HISTORIC AND DESIGN REVIEW COMMISSION

March 01, 2023

HDRC CASE NO: 2023-063
ADDRESS: 145 NAVARRO ST
LEGAL DESCRIPTION: NCB 986 LOT 11 THRU 13 AND E 5.14FT OF 10
ZONING: D, H, RIO-3
CITY COUNCIL DIST.: 1
APPLICANT: Peter Ketter/Sandvick Architects Inc.
OWNER: Kunal Mody/145 NAVARRO LLC
TYPE OF WORK: Rehabilitation, construction of a rooftop addition, exterior modifications, window and storefront system replacement, signage
APPLICATION RECEIVED: February 10, 2023
60-DAY REVIEW: Not applicable due to City Council Emergency Orders
CASE MANAGER: Edward Hall
REQUEST:

DRAWING NUMBER:
C2.0

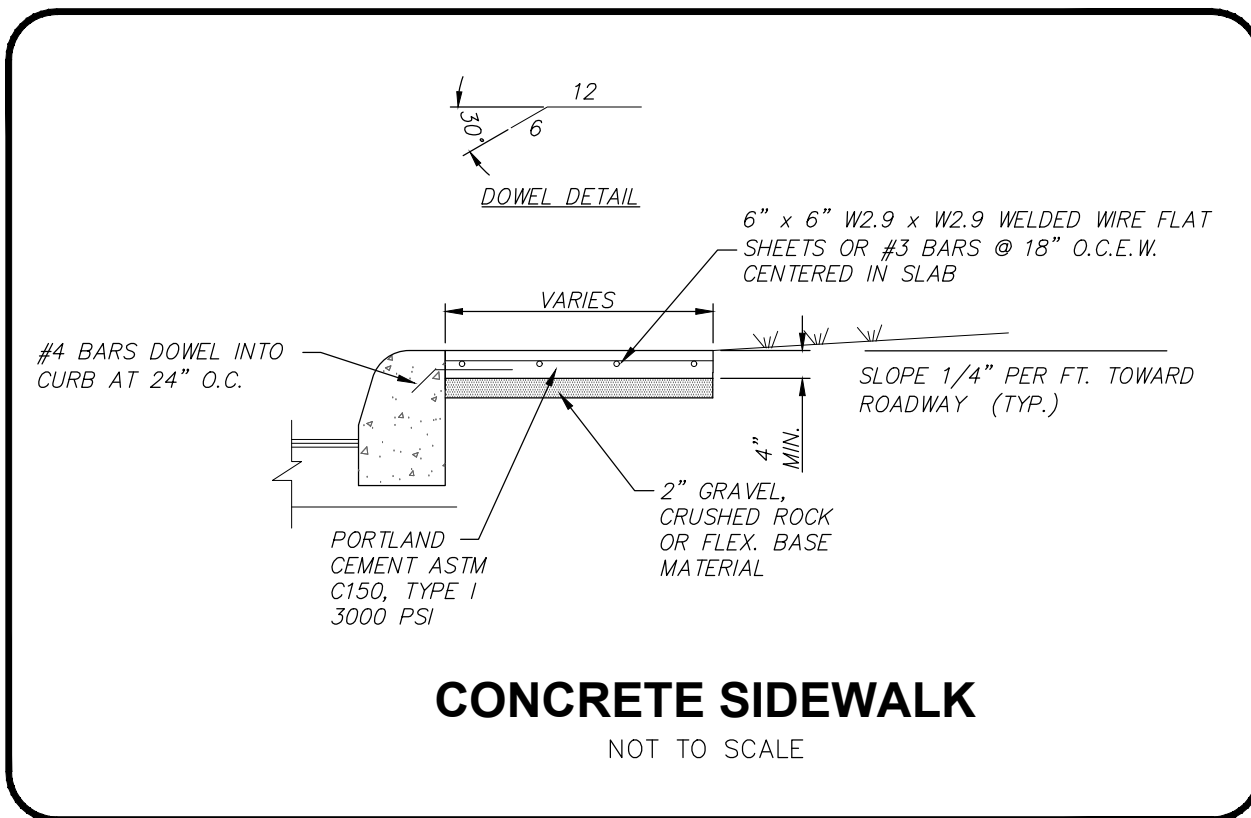
- n. RIGHT OF WAY MODIFICATION – The applicant has proposed to install two (2) concrete parkways within the existing public right of way to create reserved parallel parking stalls within the right of way on Villita Street. The proposed parallel parking will extend approximately 8’ – 6” into the right of way. Parallel parking currently exists in this space. The applicant has noted coordination with Public Works Department. Generally, staff finds the proposed parkway installations to be appropriate; however, staff finds that a street tree or landscaping beds should be incorporated in each curb. The applicant should follow the Downtown Design Guide’s sidewalk and street planting standards as outlined in Chapter 2, Section A and Chapter 8, Section E.

- 9. Staff recommends approval of item #9, the installation of two concrete parkways based on finding n with the following stipulation:
 - i. That street trees or landscaping beds be installed in each parkway. The applicant is to follow the Downtown Design Guide’s sidewalk and street planting standards as outlined in Chapter 2, Section A and Chapter 8, Section E.
